PROJECT REFERENCE NO.	SHEET NO.
R-5021	UC-62
DESIGNED BY: MEP	
DRAWN BY: MEP	
CHECKED BY: BMB	
APPROVED BY: BMB	
REVISOR:	
NORTH CAROLINA DEPARTMENT OF TRANSPORTATION	UTILITY CONSTRUCTION PLANS ONLY
UTILITIES ENGINEERING SEC. PHONE: (919) 707-6690 FAX: (919) 250-4151

UTILITY CONSTRUCTION

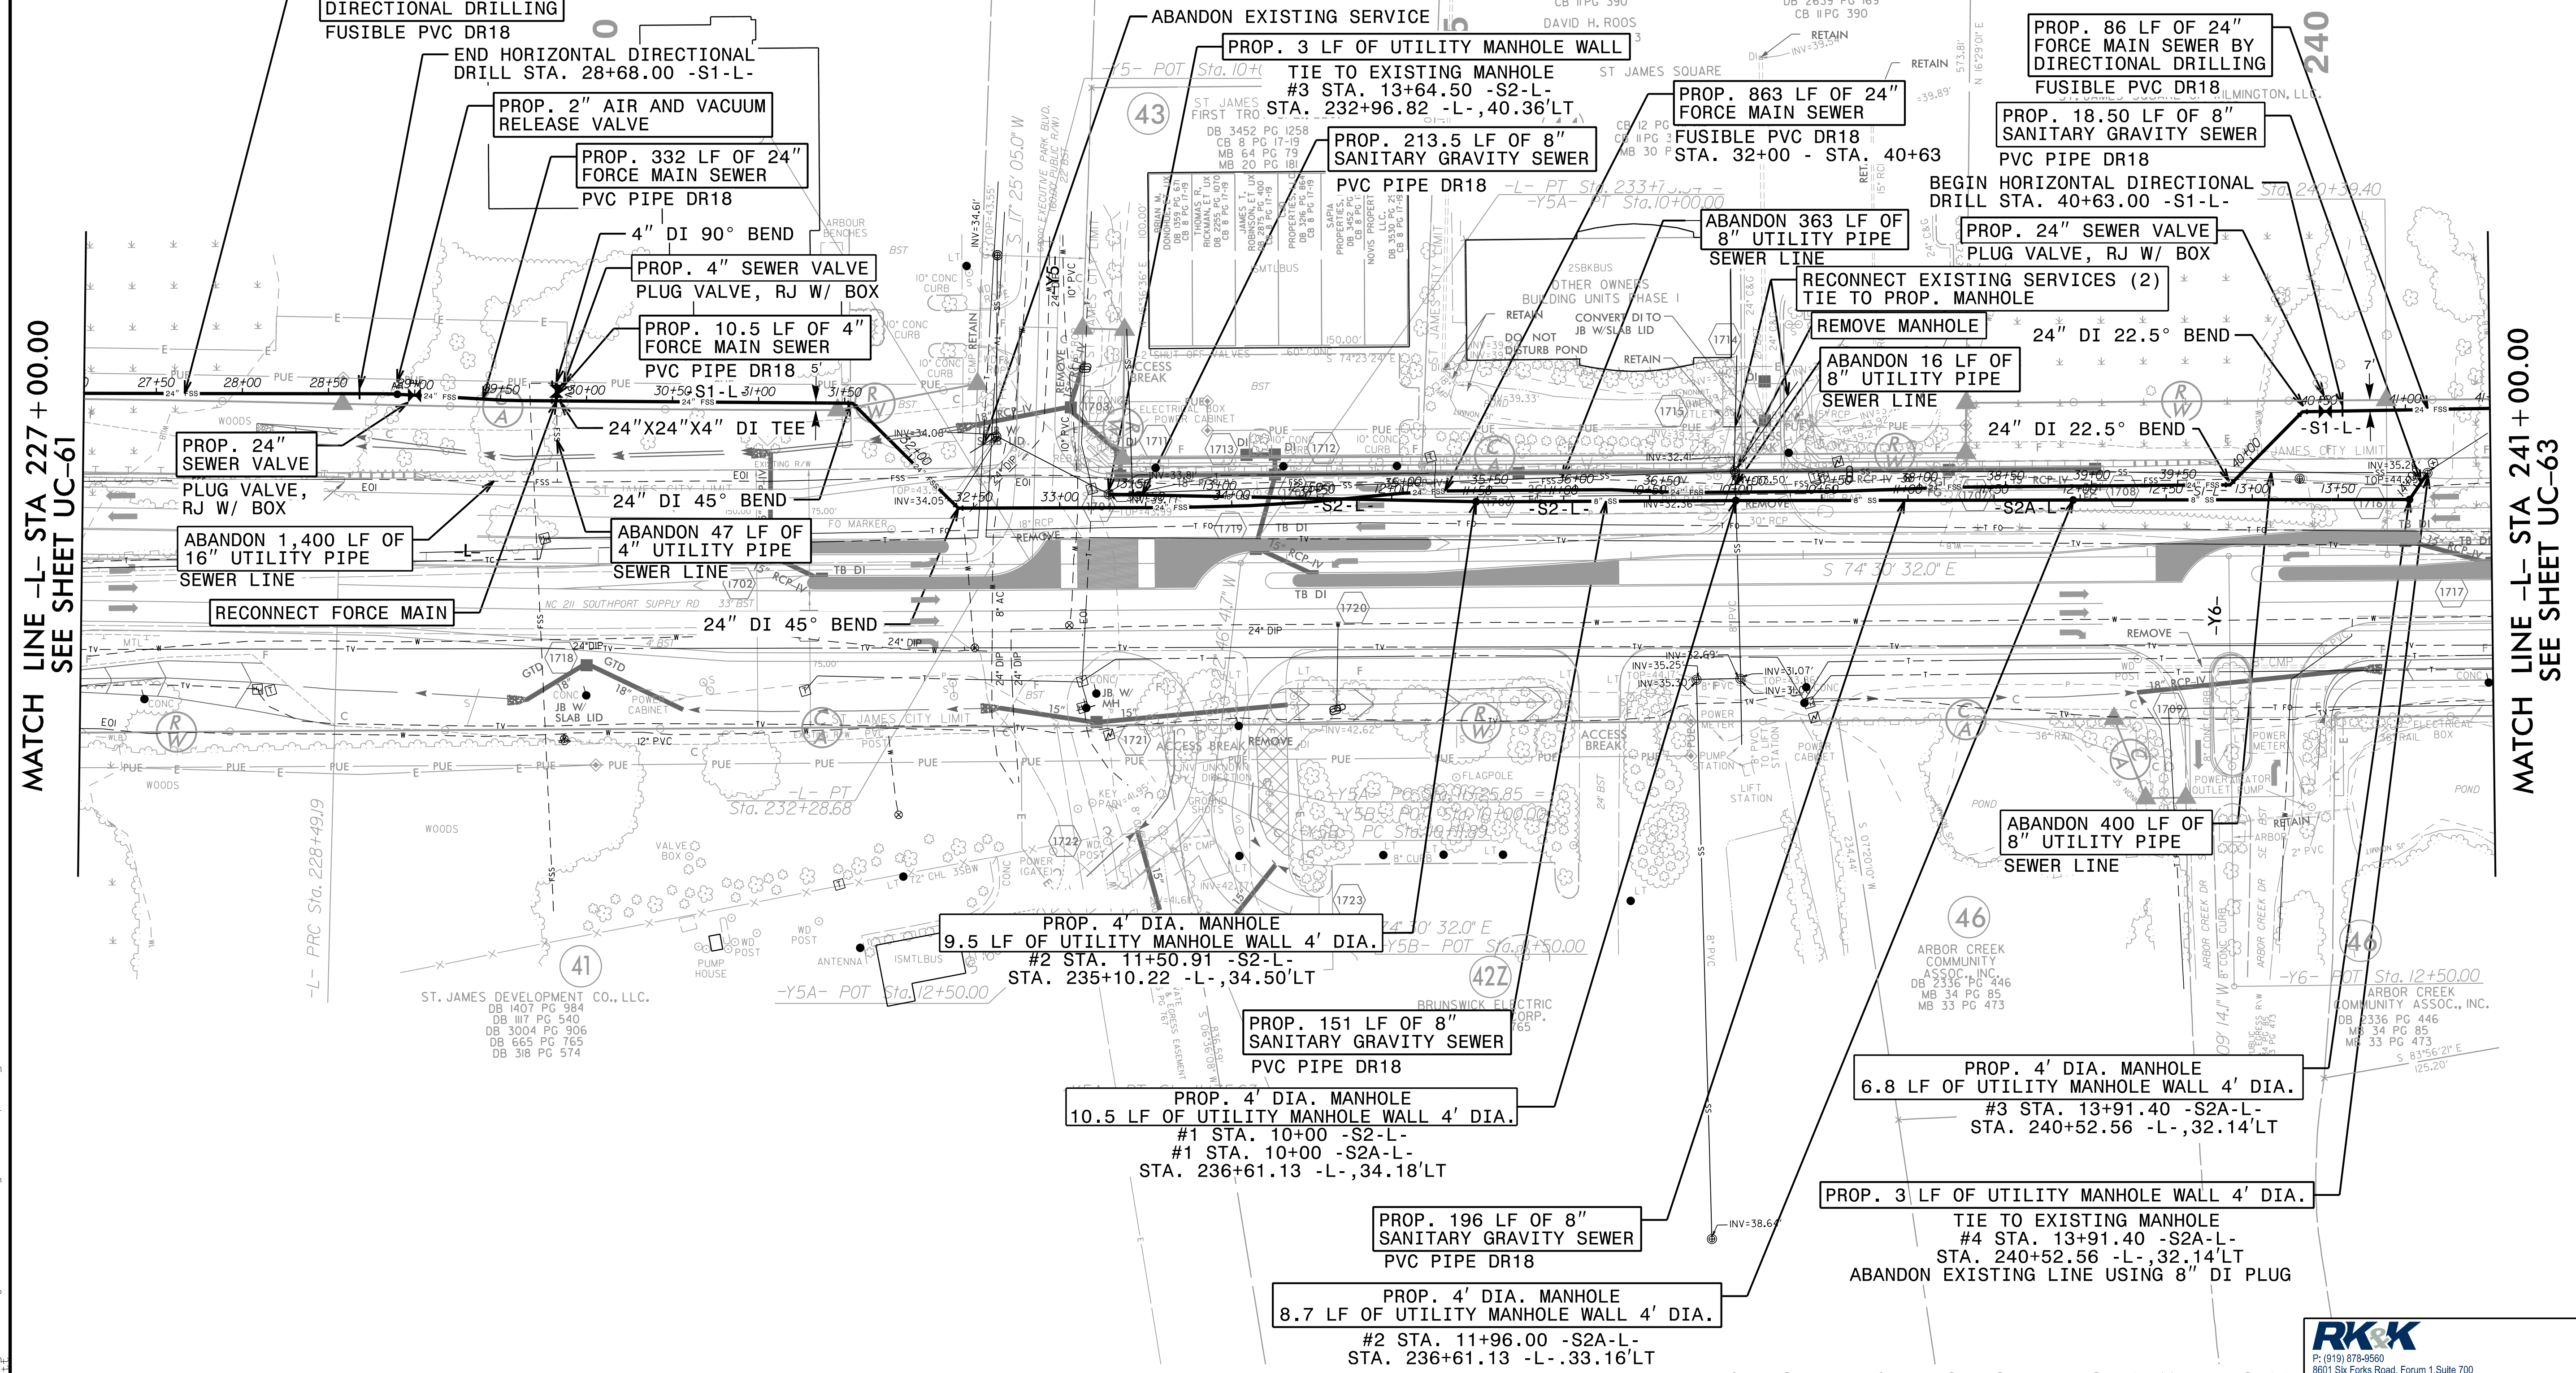
1. UPSIZED 16" FSS TO 24" FSS
2. REMOVED NOTE "RECONNECT FORCE MAIN" ON PARCEL 43
3. REVISED SEWER ALIGNMENT -S2-L- TO EXTEND TO EXECUTIVE DR.
4. ADDED 3LF OF UTILITY MANHOLE WALL
5. ADDITIONAL ABANDONMENT OF 8' GRAVITY SEWER FROM 150 LF TO 363 LF
6. PIPE MATERIAL CHANGE FROM DI PC350 TO PVC DR18 FOR SEWER LINE -S2-L- & -S2A-L-
